**NOTICE OF ADDENDUM
ADDENDUM NO. 2**

**CONTRACT NO. 7939
MADISON MUNICIPAL BUILDING - RENOVATION**

This addendum is issued to modify, explain or correct the original Drawings, Specifications, or Contract Documents and is hereby made a part of the contract documents.

3 WEST ELEVATION CHIMNEY DETAIL
BE 356 SCALE: 1/2" = 1'-0"

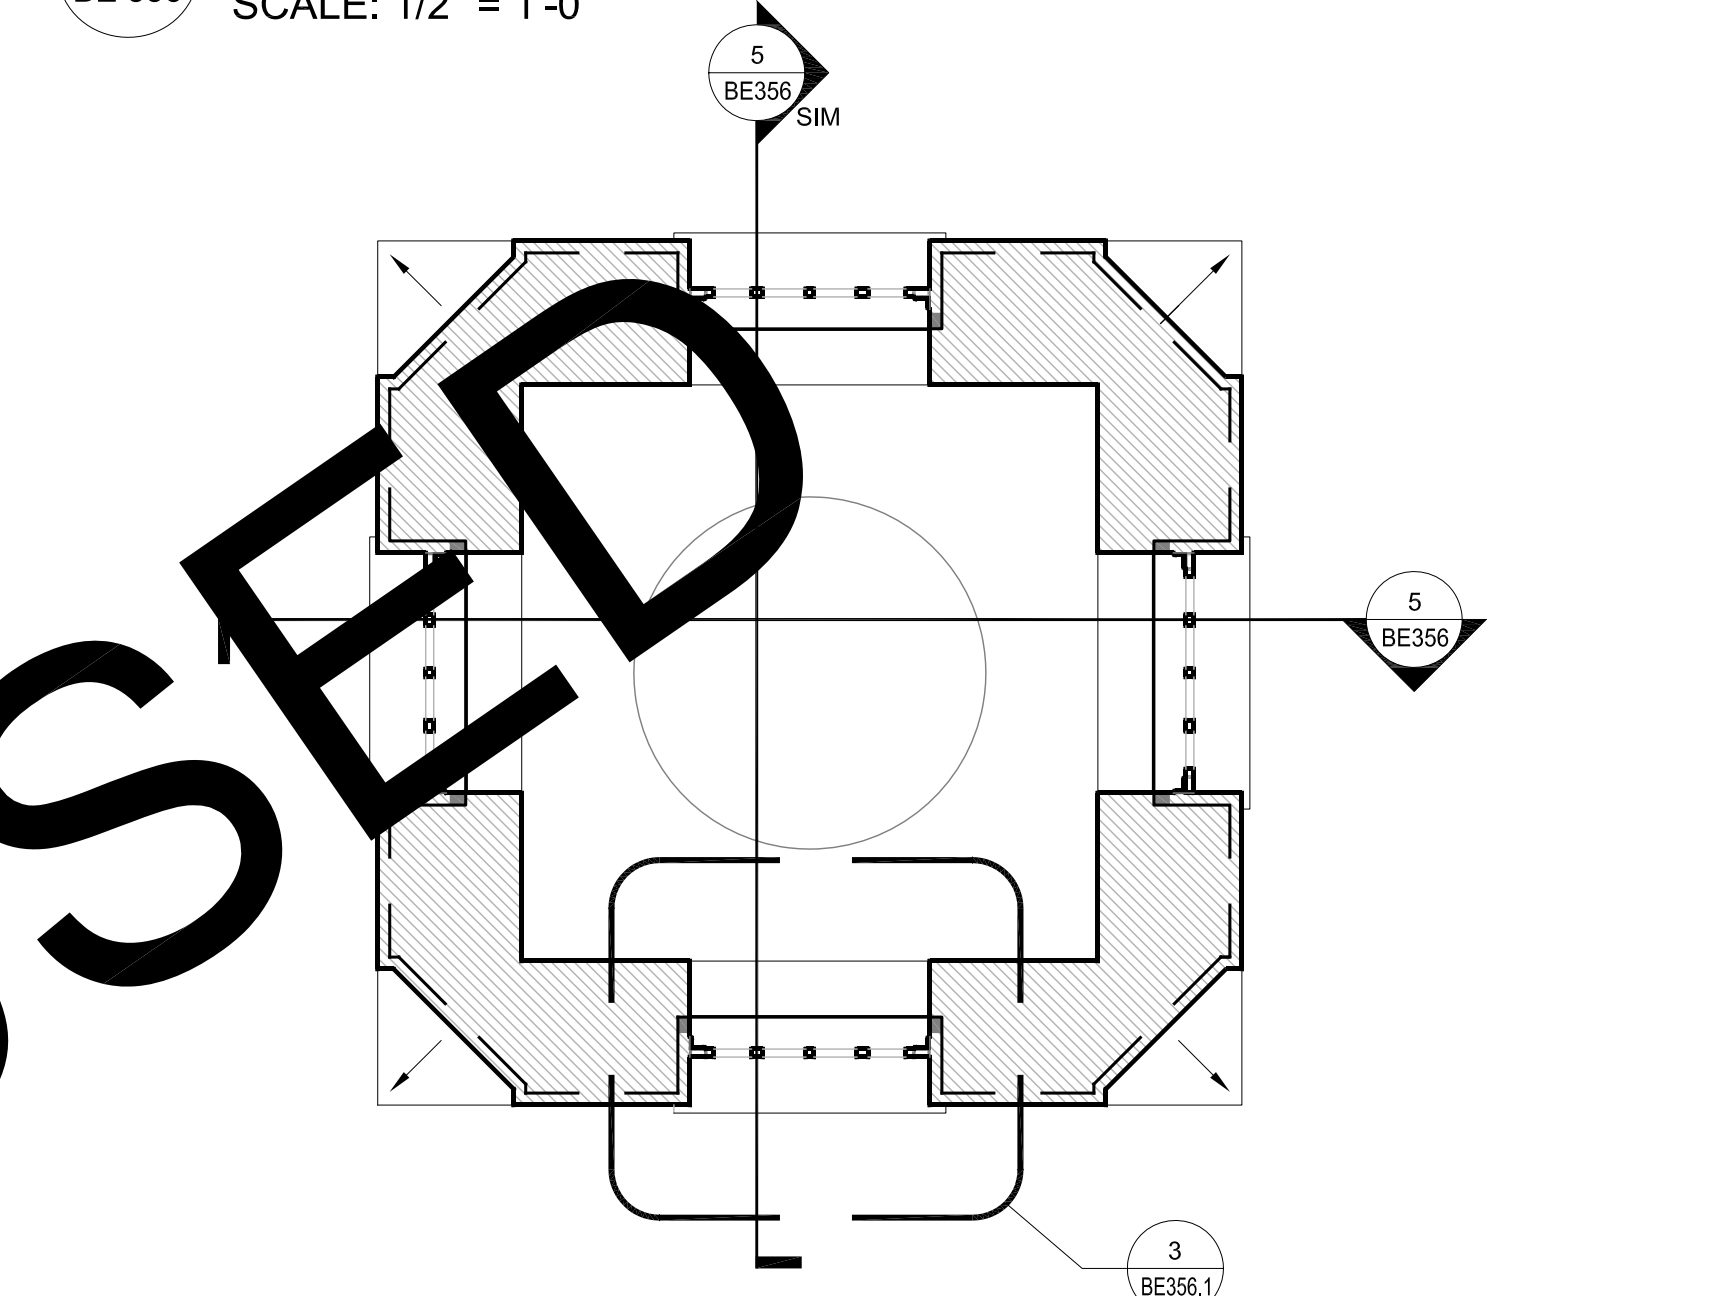
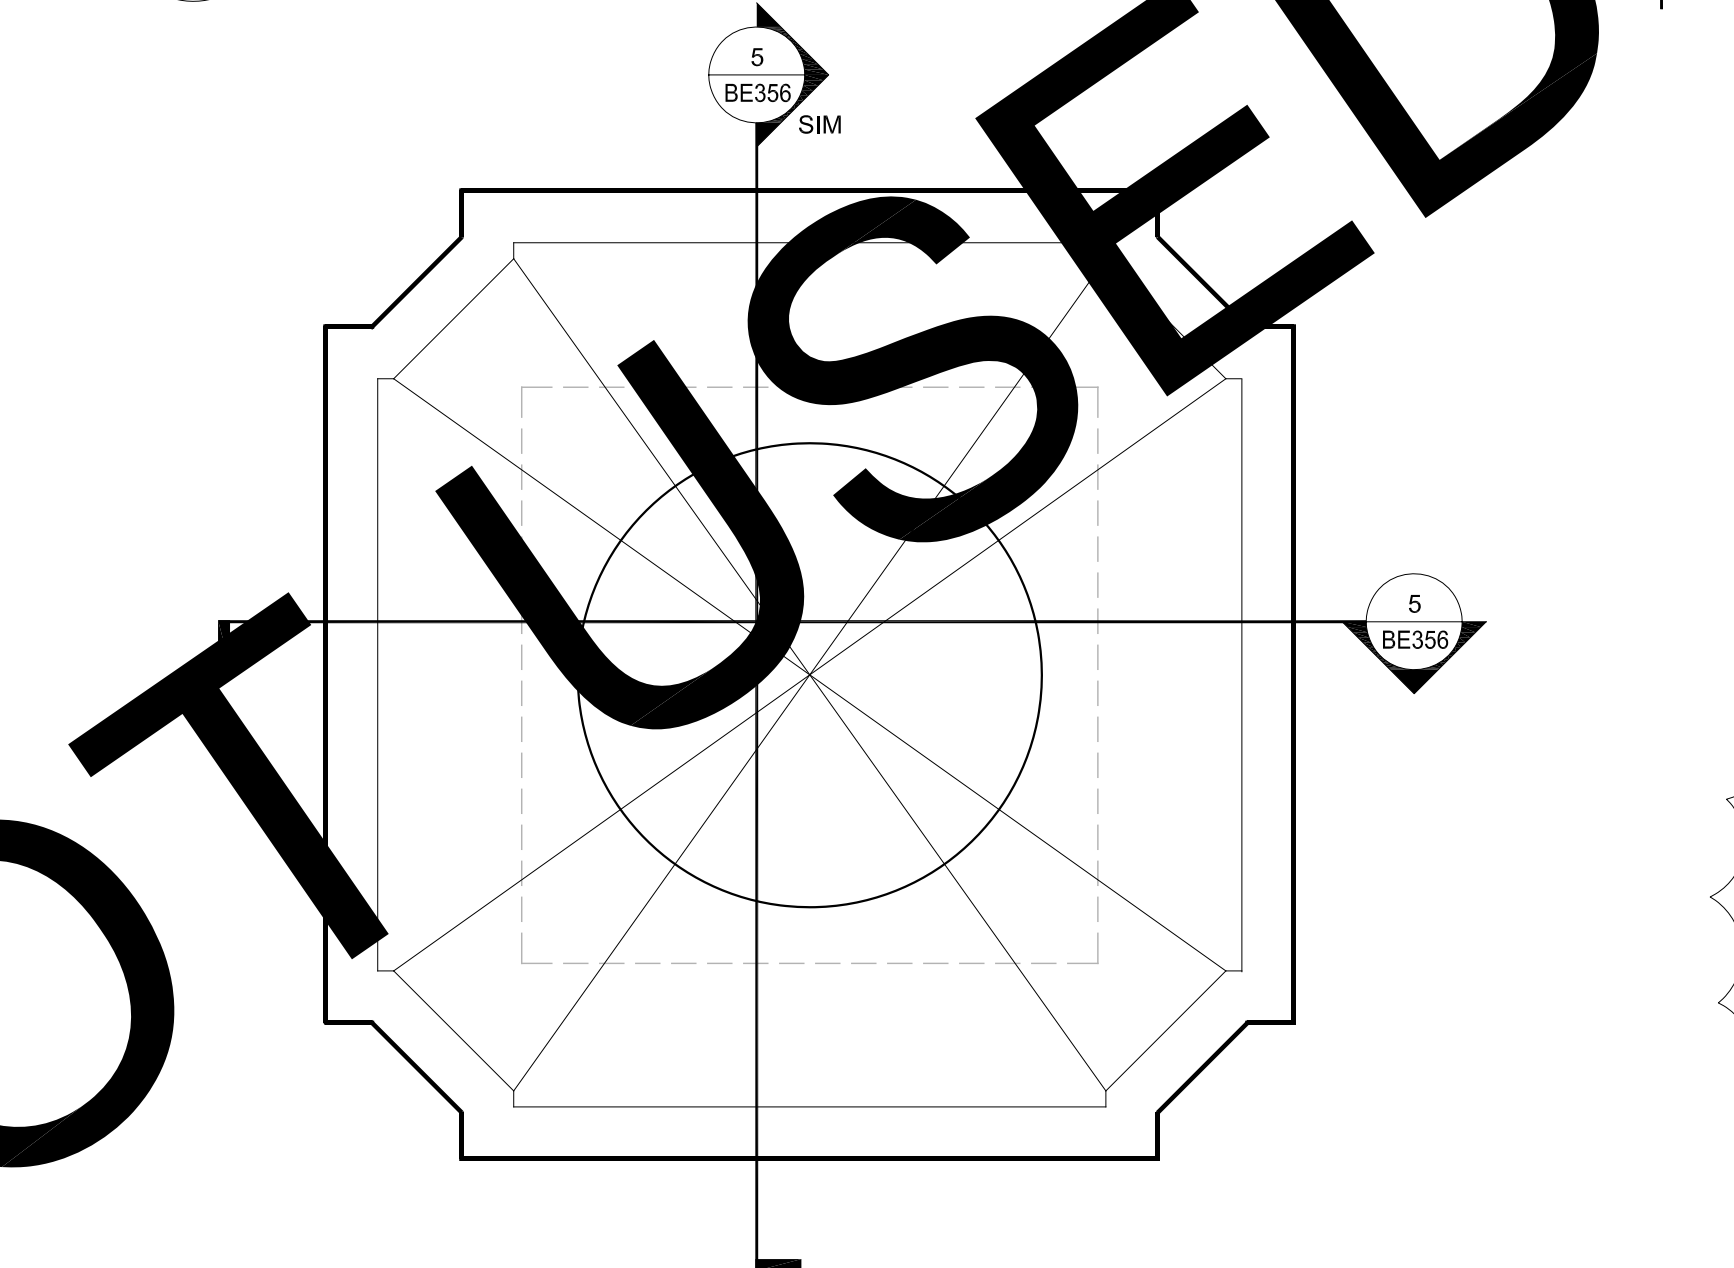
Answer: See revised Exhibit G attached with this Addendum.
14. **Question:** Sheet BE356 detail 7 states to reuse existing chimney cap while detail 1/BE356.1 (and elevations on A201) state to provide a new cap. Please clarify if we are to reuse or provide a new chimney cap.

NOTE: IN LIEU OF PREVIOUSLY DESCRIBED WORK - CHIMNEY SCOPE SHALL ONLY CONSIST OF NEW LEAD CAP FLASHING ON THE EXISTING CHIMNEY CAP
